Title SolderingStation_Power.SchDoc		
Size A4	Number	Revision 4.0
Date: 9-03-2021		Sheet of
File: Z:\Documents\..\SolderingStation_Power.SchDoc

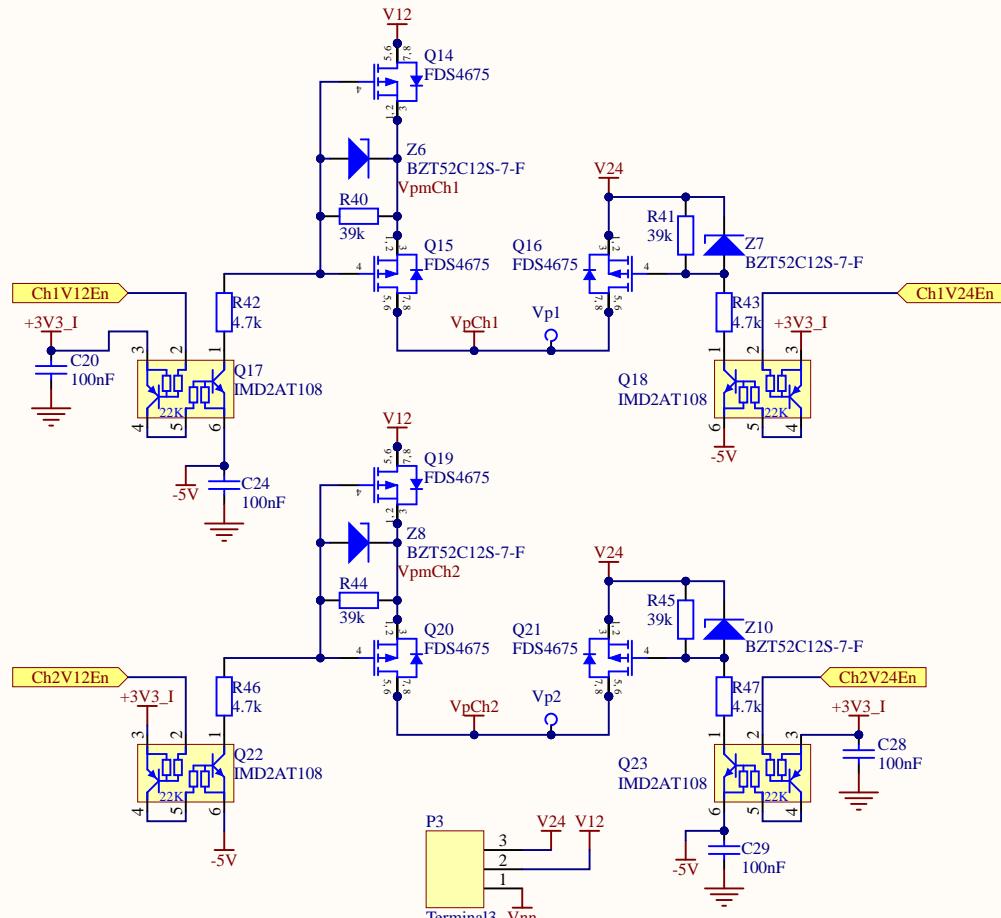
V1
- Initial release

V2
- Added Setback
- Changed current source IC etc.
- Added voltage reference for ADC

V3
- Board Dimensions altered
- Simplified NTC cct. (linearity not required)
- Removed unused components
- Isolated USB
- Prevented TC amp saturating
- Power LEDs directly driven
- Overcurrent directly measured
- Decoupled 3V3 supplies (noise from OLED)
- Added MUX and lots of related changes
- Changed to 4 channels (2 pairs)
